Work Order ID 114599

Item Name: Aft, Center Ceiling Panel

Description: Aft Center Ceiling Panel		Work Order:	114599
Inspection Drawing: 4634-5	Rev: F	Part Number:	D4634-5

From: Roberto Fuentes
Sent: Wednesday, April 23, 2014 5:06 PM
To: Eric Downing
Cc: Patrick Smith; Nigel Forbes; Mike Petsche; Harvey Siemens
Subject: RE: D4634-5

D4634-5 AFT, CENTER CEILING PANEL

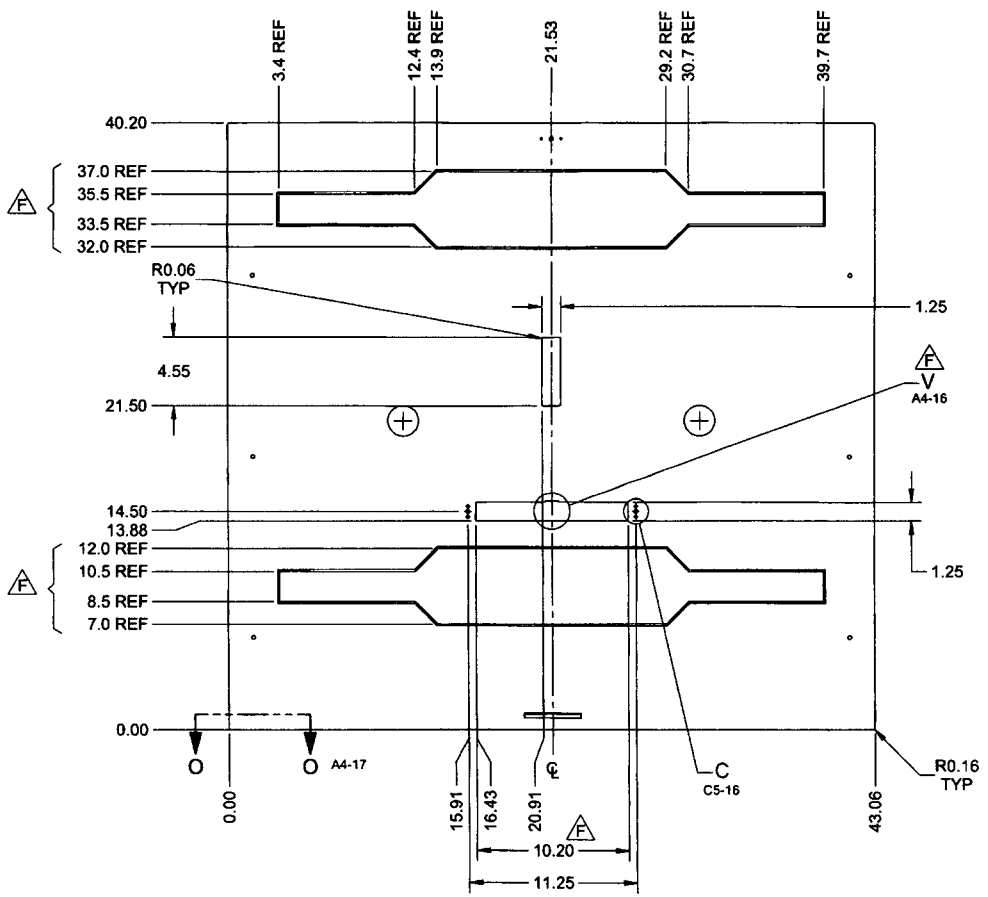
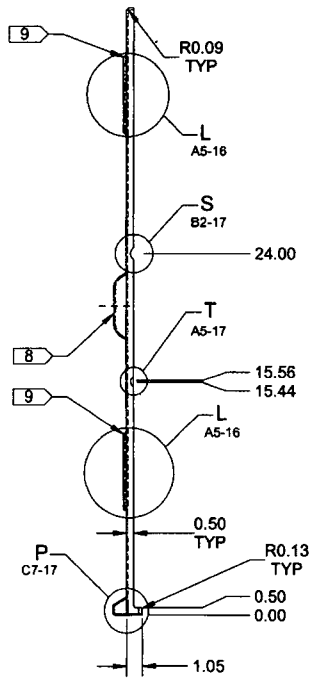
During an inspection I have found that on D4634-5 aft center panel the center cut out that's located @21.50" +/- 0.030" is measuring 21.375". I have checked the cutting & drilling template myself and have found that it is measuring wrong.

Is this deviation acceptable? And please check the DFX file for the template Roberto to ensure that it is correct.

Yes this deviation is acceptable. I don't think we are going to update this drawing in near future just for this, my recommendation if easy for Daryl to modify his template, if not use this e-mail for accept this deviation.
